PREPARED	NAME L. Pazmany	Mar. 7-73	PAZMANY AIRCRAFT CORPORATION — SAN DIEGO — CALIFORNIA —	MODEL NO.	PL-4A
CHECKED			ENGINEERING CHANGE NOTICE #1	REPORT NO.	
APPROVED				PAGE NO.	1

DWG 4-10-001 - WING ASSEMBLY - (OPTIONAL CHANGE)

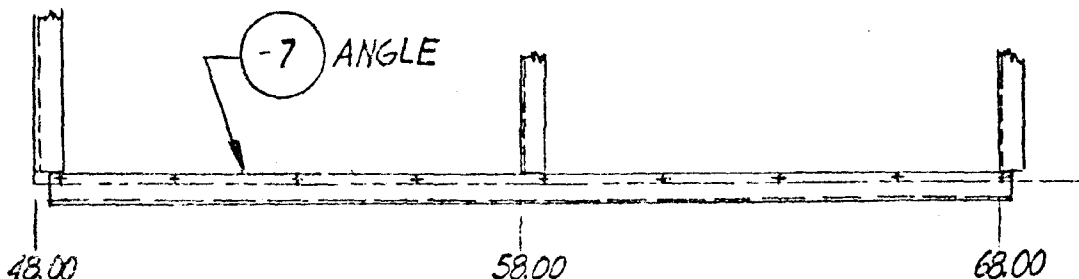
DURING FLIGHT TESTING IT WAS FOUND THAT THE LEFT WING DROPPED FIRST CONSISTENTLY. THIS COULD BE A RESULT OF A MISSALIGNMENT OF THE WINGS. THIS TENDENCY WAS CORRECTED BY ADDING ANOTHER STALL STRIP IN EACH WING PANEL AS SHOWN ABOVE. THIS COULD BE A PARTICULAR SITUATION WITH THE PROTOTYPE ONLY, AND MAY NOT BE REQUIRED IN YOUR AIRPLANE. IF YOU FIND THE SAME SITUATION IN YOUR AIRPLANE, INSTALL STALL STRIPS AS SHOWN ABOVE BUT ONLY TAPPED TO BEGIN. RIVET STALL STRIPS IF IT HELPED.

DWG 4-50-003 - AILERON CONTROL INSTALL.

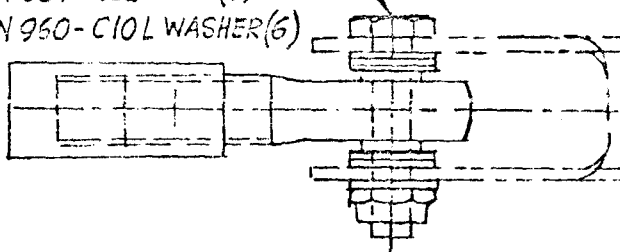
NAS 1103-12 BOLT (1) (MANDATORY CHANGE)  
AN 364-1022 NUT (1) TO CORRECT ERROR  
AN 950-C10L WASHER (6)

DWG. 4-30-002 - FIREWALL ASSEMBLY.

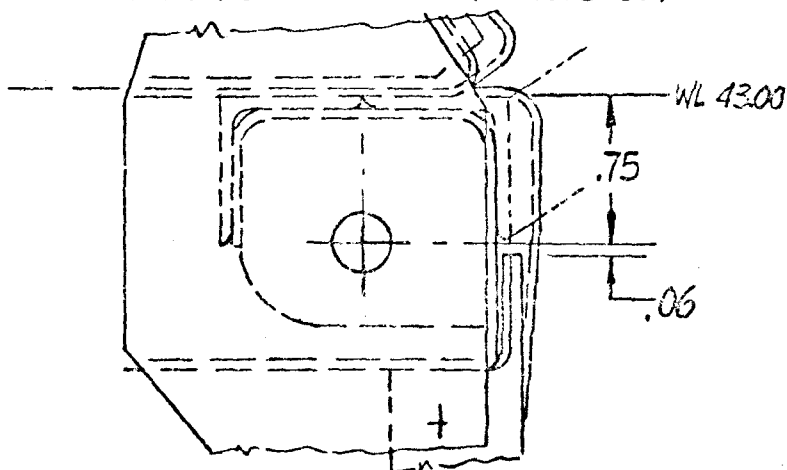
(MANDATORY CHANGE) - TO CORRECT ERROR DRAWING WAS OUT OF SCALE. LOCATION OF HOLE FOR ENGINE MOUNT BOLT WAS SHOW AT .67 BELOW WL 43.00. ALSO CORRECT LOCATION OF THIS HOLE IN DETAIL OF -31 GUSSET

DWG. 4-30-002 - FIREWALL ASSEMBLY

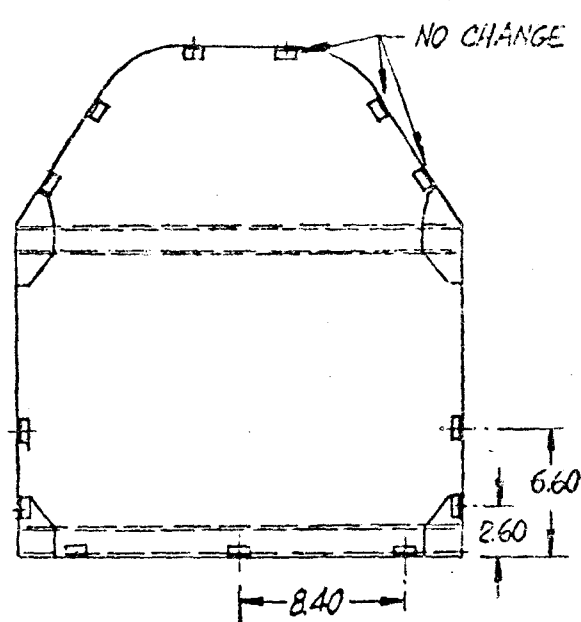
(MANDATORY CHANGE) - TO CORRECT ERROR.

THE LOCATION OF -19 ANGLES WAS CHANGED AT THE TIME OF INSTALLING THE COWL. THIS CHANGE WAS NOT INCORPORATED IN THE FIREWALL DWG. THE ANGLES -19 AND THE CAMLOC RECEPTACLES FOR THE UPPER COWL ARE NOT CHANGED. THE ANGLES -19 FOR THE BOTTOM COWL ARE RELOCATED AS SHOWN. USE NAS 697-A08K NUTPLATES (7 PLACES) INSTEAD OF CAMLOCKS FOR THE BOTTOM COWL.
